Re: Response to Comments  
Breckenridge Disposal Site, St. Louis, Michigan

ENVIRON International Corporation (ENVIRON), on behalf of the Custodial Trust provides the below responses to your October 2, 2006 comments to our September 19, 2006 Supplemental Site Characterization Work Plan. We have endeavored to address the NRC comments in a manner that is consistent with our discussions with NRC staff during our most recent June 22, 2006 meeting. Some of your comments raise questions on issues that we had understood to have been resolved. We hope that this response to comments letter will resolve the outstanding questions so that our Supplemental Site Characterization Field Work may proceed. In light of the fact that time is of the essence, should you not find our responses acceptable, we respectfully request that another meeting be convened with the NRC to affirmatively resolve any outstanding issues.

**Figure 1: Dilution Factor Calculation**

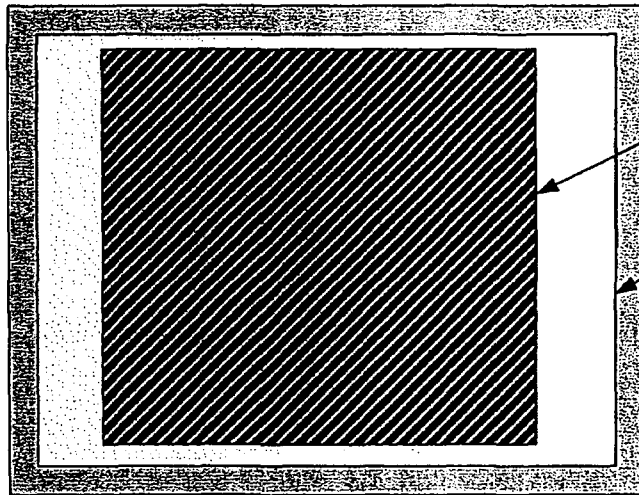
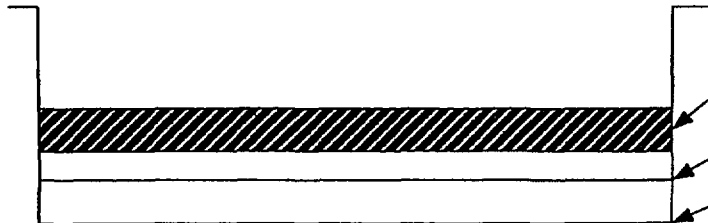
*Comment 1. Please confirm that the subsurface soil with subsurface DCGL, when brought to the surface, will not exceed the surface DCGL. In other words, the subsurface DCGL should be less than surface DCGL times dilution factor (Contaminated soil mixed with nearby clean soil when brought to the surface).*

**Response:** As discussed in ENVIRON's August 3, 2006 letter, a reasonable scenario in which material would be brought to the surface is a construction of a house with a basement. It is reasonable to assume that during excavation, the soil is thoroughly mixed and the resulting concentration is equal to the average activity level of the soil volume excavated. This mixing can be calculated by developing a dilution factor. The following equation will be used to calculate the dilution factor.

The calculation of the volume is shown on Figure 1. The calculated dilution factor is 9.1. As shown in Table 1, the subsurface 2006 DCGLs are protective of human health even if brought to the surface.

$$V_{\text{excavation}} = 34' \times 44' \times 10' = 14,960 \text{ cubic feet}$$

$$V_{\text{impacted}} = 824 \text{ square feet} \times 2' = 1,648 \text{ cubic feet}$$

$$DF = 14,960 \text{ cubic feet} / 1,648 \text{ cubic feet} = 9.1$$
